Amendments to the Drawings:

REMARKS

FIG 1

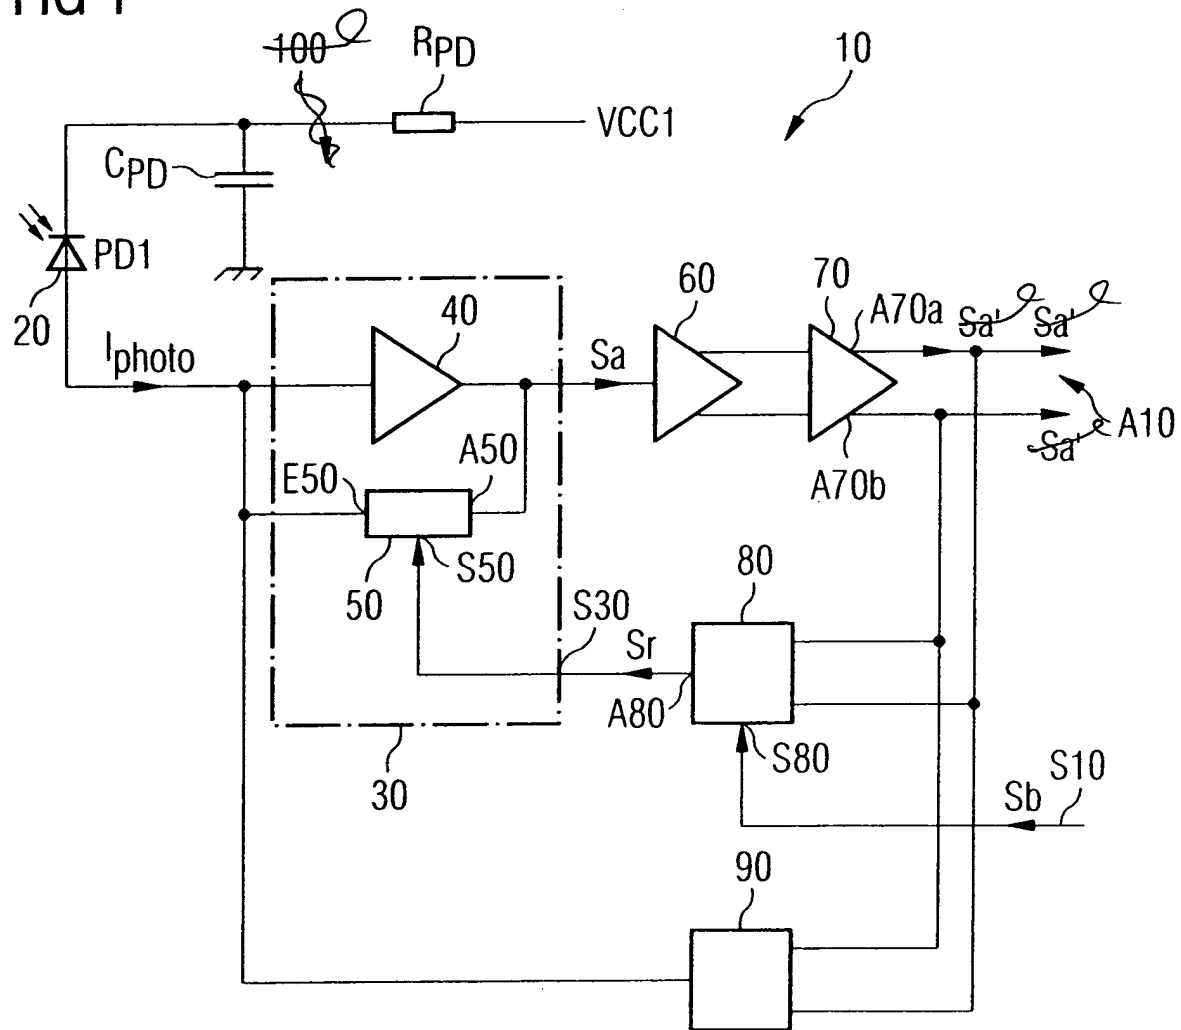
Please replace Figures 1, 3 and 4 with new Figures 1, 3 and 4 as presented in the attached drawings.

The drawings and specification have been amended to address the 37 C.F.R. §§ 1.84(p)(4), (p)(5) objections to the drawings raised by the Examiner. Reference characters not mentioned in the description have been removed. Reference characters mentioned in the specification and not included in the drawings have been added in the amended drawings. Paragraph 0055 is amended to clarify that reference resistance R_C represents a resistance and not a component resistor. Because there is no component, the reference resistance is not required to be shown in the drawings. Reference numerals 210 and 220 as shown in Figure 4 and referred to in the specification in paragraphs 0068 and 0069 have been amended to 310 and 320, respectively.
